Planning Commission Staff Report
Council Chambers
June 5, 2018 1:30pm

4. APPLICATION: **Kentucky Fried Chicken | Development Plan**

Project Number: 201805020017

Site Plan

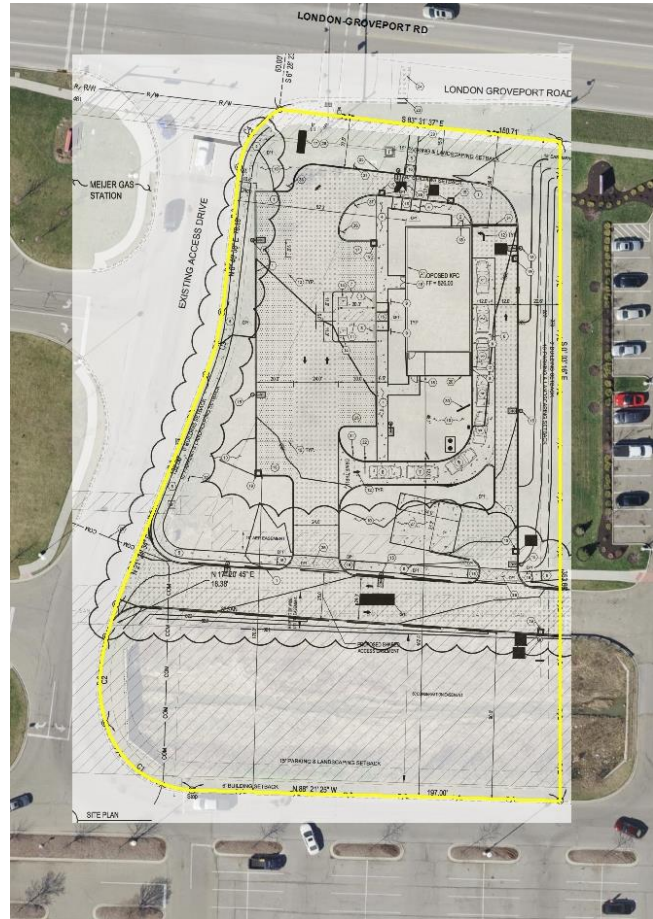
A number of sidewalks are proposed to provide connectivity internally as well as to the public walk along SR665. A 5-foot sidewalk is proposed north of the shared access drive and runs the entire width of the property, connecting with the existing sidewalk along SR665. A second 5-foot sidewalk is proposed around the west and north portions of the building, and is proposed to connect with the existing sidewalk on SR665. Three (3) crosswalks are proposed on the site to connect the sidewalks across drive aisles; however, plan sheets are not consistent in terms of their treatment. Sheet C-111 displays these crosswalks as being stamped brick while sheet C-502 has a detail for yellow striped crosswalks. The crosswalk detail contained on sheet C-502 should be removed from plans to ensure consistency in the development.

1. All crosswalks on the site shall utilize stamped brick. The yellow-striped crosswalk detail shall be removed from Sheet C-502.
2. The site shall be grassed with sod.
3. The utility area to the rear of the building shall be finished in brick and/or EIFS matching materials utilized on the primary building.
4. Menu boards shall have brick bases that match that used on the primary structure.

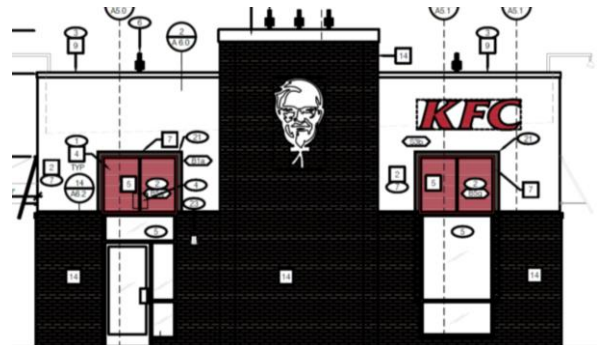
There are two (2) locations shown for proposed menu boards. Each will be in its own landscaping bed. One (1) of the menu boards will be landscaped with five (5) Pacific Blue Juniper shrubs and 11 Happy Returns Daylilies. The second will be landscaped with three (3) Pacific Blue Juniper shrubs, six (6) Polar Gold Arborvitae shrubs, 14 Goldfinger Potentilla shrubs, 11 Green Gem Boxwood shrubs, and 13 Happy Returns Daylilies. Staff is supportive of the proposed landscaping for the menu boards provided they are properly screened.

Plans state that the site will be seeded. Due to the prominence of the site from London Groveport Road at its intersection with Rings Road, staff recommends sod be utilized in place of seed on the site.

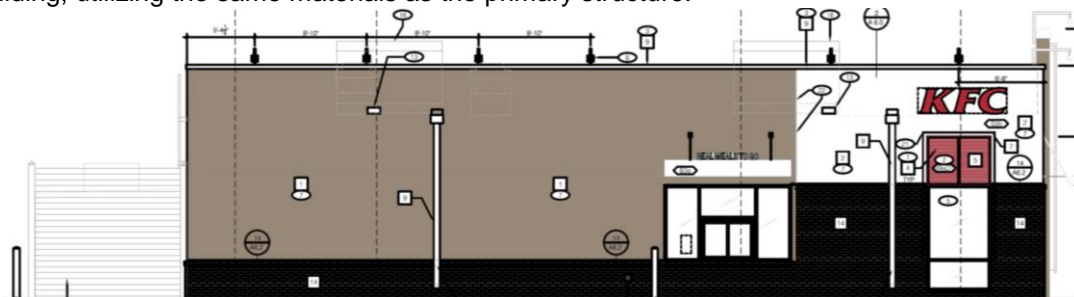
A trex fence is proposed at the rear of the building to enclose the building's utilities. While staff is supportive of enclosing utilities on the site, the enclosure should appear as an extension of the building, utilizing the same materials as the primary structure.

Menu board sign designs were also submitted which show a single panel menu board and a second three (3) panel menu board. Each one will be approximately 4' in height and be Benjamin Moore "Exotic Red" and "Wedding Veil" in color. The base of each will be aluminum and gray in color. Staff is not supportive of the proposed aluminum base and recommends that all menu boards utilize brick bases.
